PCN# 20230814004.1
Qualification of new Fab site (RFAB) using qualified Process Technology, Die Revision and additional Assembly BOM options for select devices
Change Notification / Sample Request

PCN Number:	20230814004.1	**PCN Date:**	August 14, 2023
Title:	Qualification of new Fab site (RFAB) using qualified Process Technology, Die Revision and additional Assembly BOM options for select devices		
Customer Contact:	Change Management team	**Dept:**	Quality Services
Proposed 1st Ship Date:	Nov 14, 2023	**Estimated Sample Availability:**	Sep 14, 2023*

Sample product shipping label (not actual product label)

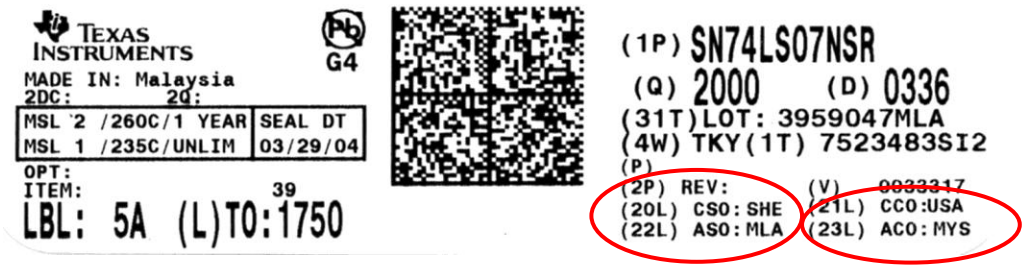
Changes to product identification resulting from this PCN:

Fab Site Information:

Chip Site	Chip Site Origin Code (20L)	Chip Site Country Code (21L)	Chip Site City
SH-BIP-1	SHE	USA	Sherman
RFAB	**RFB**	**USA**	**Richardson**

Die Rev:

Current	**New**
Die Rev [2P]	**Die Rev [2P]**
A, -	**A**
